Service Advisory

CC-537A

Series 2000/2500

Subject: **759-04136A Hood Service Kit**

UNIT WITHOUT HEAT SHIELD EXTENSION

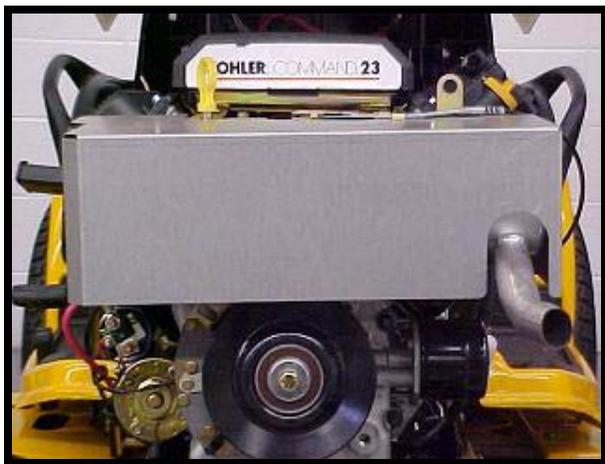
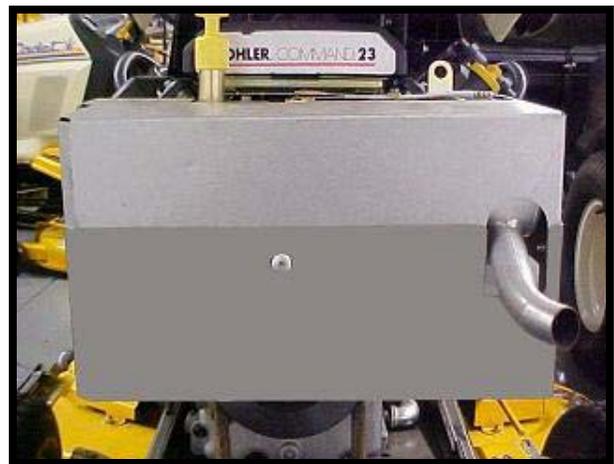
PURPOSE: When a hood is required and the unit is without a heat shield extension, order **759-04136A Hood Service Kit**. This service kit includes a hood plus an additional exhaust heat shield to help redirect heated exhaust air away from the lower portion of the hood and latch assembly area.

UNIT WITH HEAT SHIELD EXTENSION

FIGURE 1

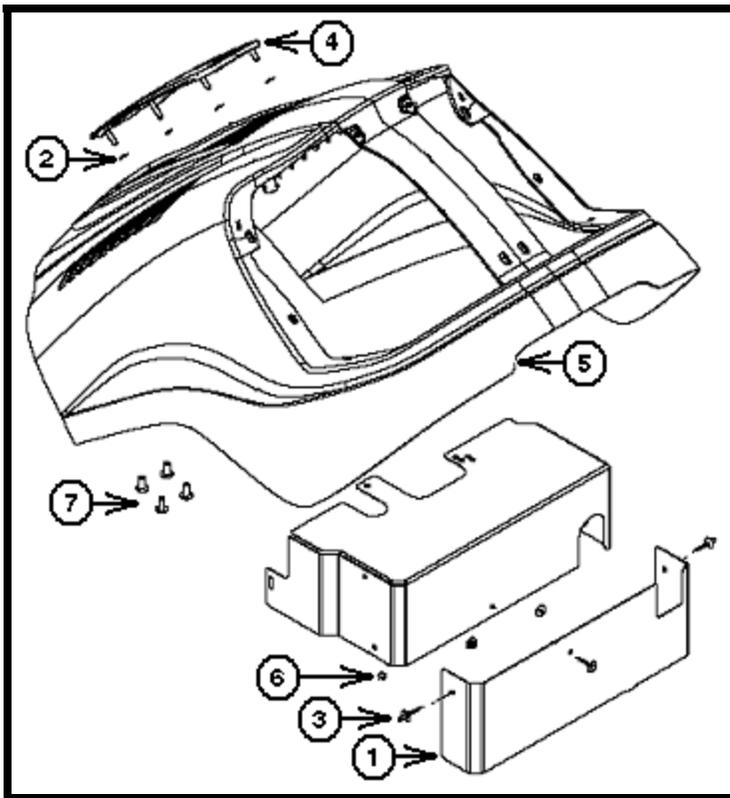
Service Kit Contents 759-04136A
